MIDWEST POOLED FUND PROGRAM

**Progress Report
First Quarter 2009
January 1st to March 31st (Actually Through April 20th)
Midwest Roadside Safety Facility
Nebraska Transportation Center
University of Nebraska-Lincoln**

Pooled Fund Consulting Summary

Figure 1. Wisconsin Single-Slope Concrete Barrier Thrie Beam Transition

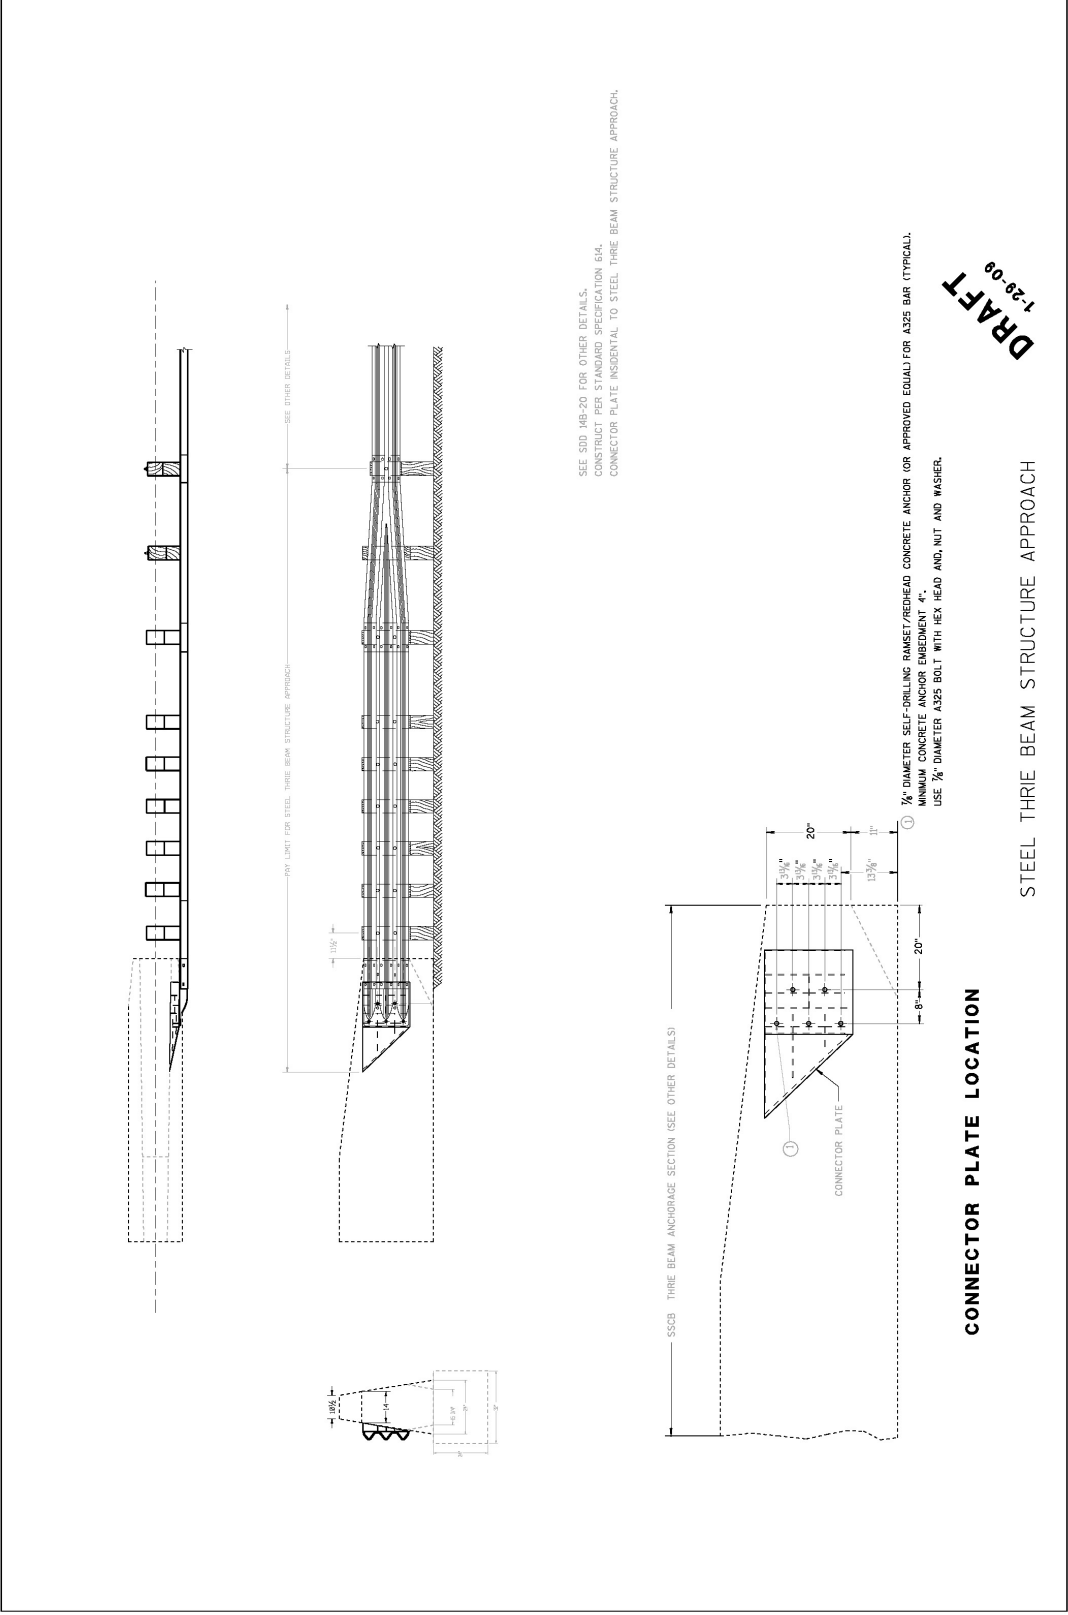
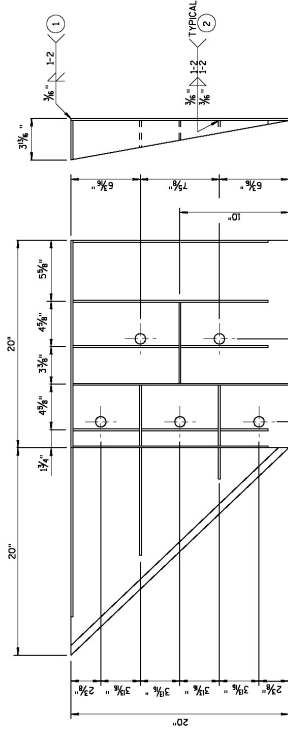
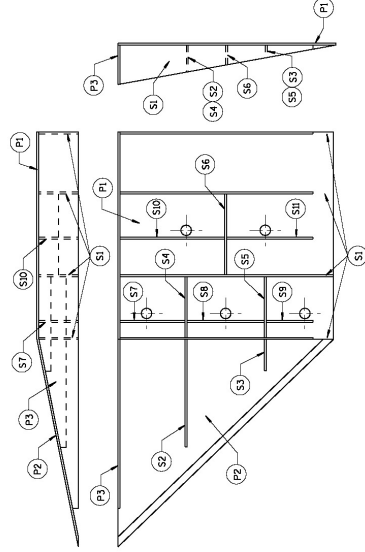
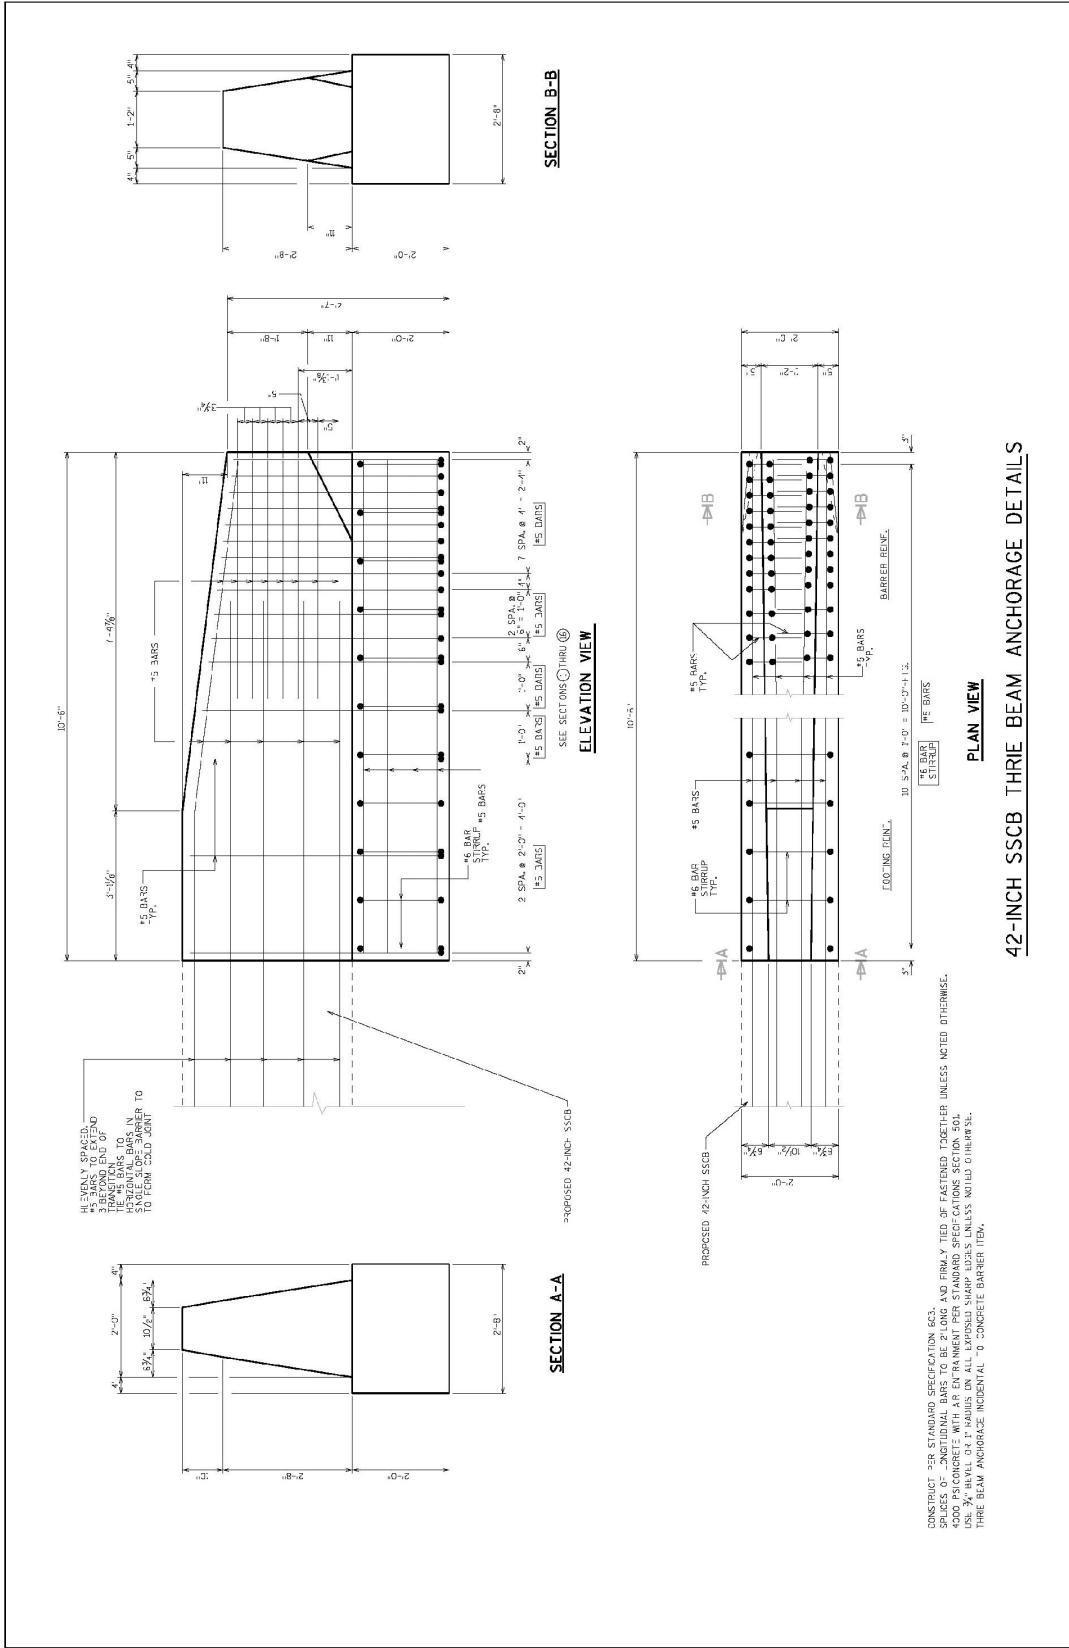
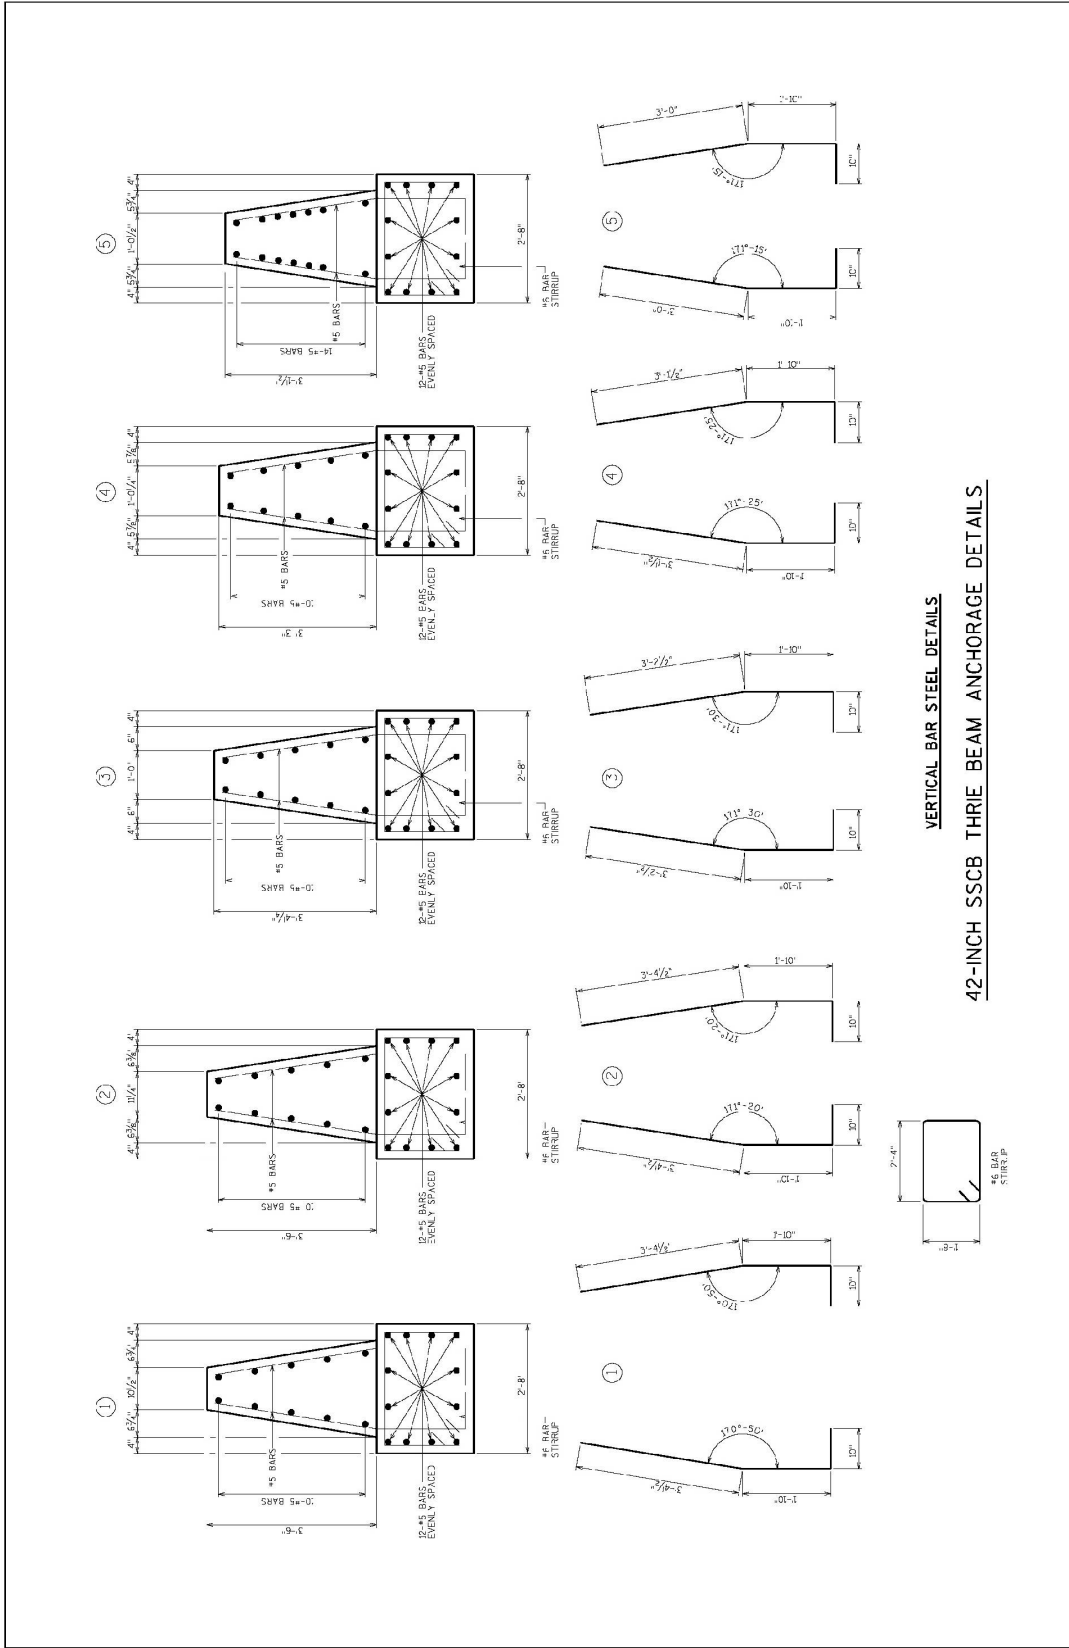
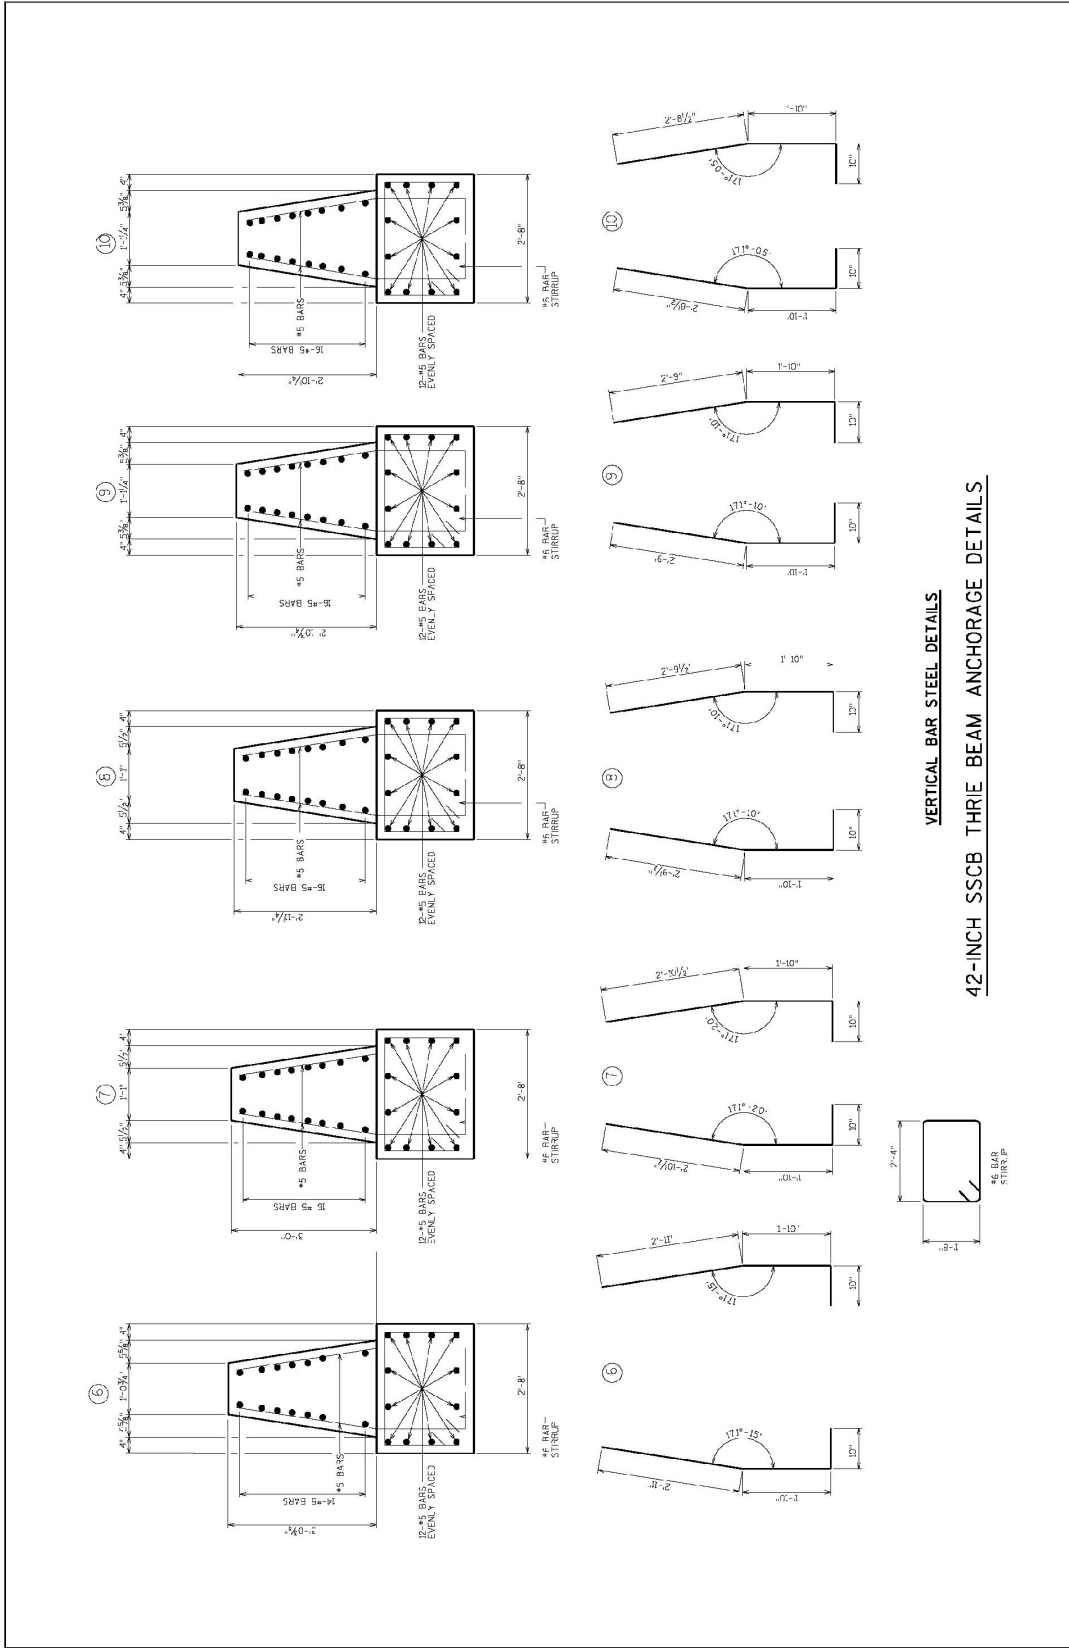
For your new detail, I briefly glanced through the pages but did not see anything glaringly out of order. However, please note that I did not check dimensions, bar sizes, bar locations, or bar quantities. It appears that you have adapted transition details from a wood post variation of the Iowa Pooled Fund design from the mid- to late 90s. It is also recognized that you utilized the steel adaptor plate from a prior Missouri Pooled Fund design from the mid 90s. Various cross sectional views are also provided. However, I do not see where they are shown on the plans. In addition, it may be worth considering the use of some vertical bars over the first 4-5 ft to the left of the cold joint since a significant change in geometry occurs here when considering the loss of the foundation system.

At the present time, Bob is looking into alternatives for attaching the thrie beam end shoe and adaptor plate to the single slope barrier face. It should be noted that the embedded anchors utilized in the research study may no longer be available. For roadside applications, through bolts may be used as an option. We should wait to see what Bob comes up with for other anchorage options.

First, the original transition that was tested anchored the three beam to the single slope barrier using 7/8" diameter A325 bolts with "self-drilling" Redhead anchors. These anchors had a listed capacity of 20.5 kips in pullout/tension and 24.32 kips in shear. The higher grade bolt was required to address bending of the bolt. The issue that arises is that this anchorage is no longer made. Thus, we looked through the available alternatives.

1. There are not currently available drop-ins or wedge bolt type anchors that are 7/8" diameter nor are any made in high grade steel. It is possible to get 3/4" diameter anchors that meet the 20.5 and 24.32 kip anchor loads, but the bolts will not handle the same bending loads as those in the original design.

2. There are 7/8" diameter mechanical stud anchors available, but neither is available in high grade steel. Thus, they may not be strong enough for the bending loads. Also, studs are not as easy to use as the original anchors and there is some snag potential on the heads.

3. Bolting through is a potential option and is likely the best option for a roadside installation. For median installations, the ends of the bolt present a snag potential similar to the stud anchors mentioned above.

4. Another option for attachment would be epoxied threaded rod. 7/8" diameter, B7 threaded rod would be stronger than the bolts in the original design and could be epoxied into the concrete. Based on a review of the available epoxies from Powers Fasteners and RedHead, it appears that they would require approximately 7 7/8" of embedment. This may be difficult to embed based on the width of the barrier. Also, there would be potential for snag on the threaded rod similar to the stud option.

5. Dayton Richmond and Williams Form engineering produce and design cast-in-place anchors. It is likely that they could help you develop a template to cast anchors with similar shear and tensile capacities to the originally tested anchors and that would work with 7/8" A325 bolts.

6. An alternative to all of these options would be to cast a vertical face on the end of the single-slope that matches the mounting plate used in the testing. This would eliminate the bolt bending and allow for the use of drop-ins with 3/4" diameter A325 bolts. These anchors exist and we have good experience with them. You could also use a wedge-bolt mechanical anchor in this type of option.
